[Docket No. FAA-2023-1055; Project Identifier AD-2023-00583-T; Amendment 39-22445; AD 2023-10-09]

Airworthiness Directives; The Boeing Company Airplanes

2023–10–09 The Boeing Company:

Amendment 39–22445; Docket No. FAA–2023–1055; Project Identifier AD–2023–00583–T.

Figure 1 to paragraph (g)(3)(i)—Allowable damage not extending beyond fastener hole width

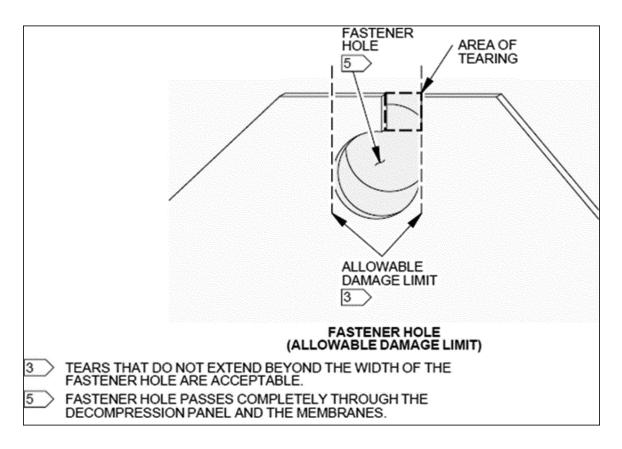
- (i) If the damage is on the fastener hole, the damage must not extend beyond the width of the fastener hole. Refer to figure 1 to paragraph (g)(3)(i) of this AD. Where figure 1 to paragraph (g)(3)(i) of this AD refers to tears or tearing, this includes all types of damage as defined in paragraph (g)(2) of this AD.

Figure 2 to paragraph (g)(3)(ii)—Allowable damage not extending more than fastener hole diameter

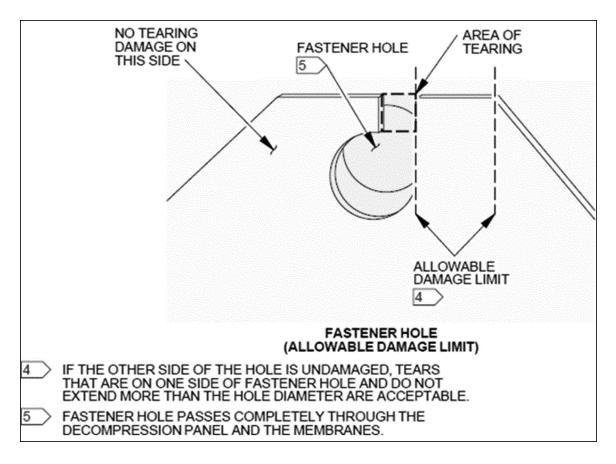
(ii) If the damage is on one side of the fastener hole and the other side of the fastener hole has no damage, the damage must not extend more than the diameter of the fastener hole. Refer to figure 2 to paragraph (g)(3)(ii) of this AD. Where figure 2 to paragraph (g)(3)(ii) of this AD refers to tears, tearing, or tearing damage, this includes all types of damage as defined in paragraph (g)(2) of this AD.
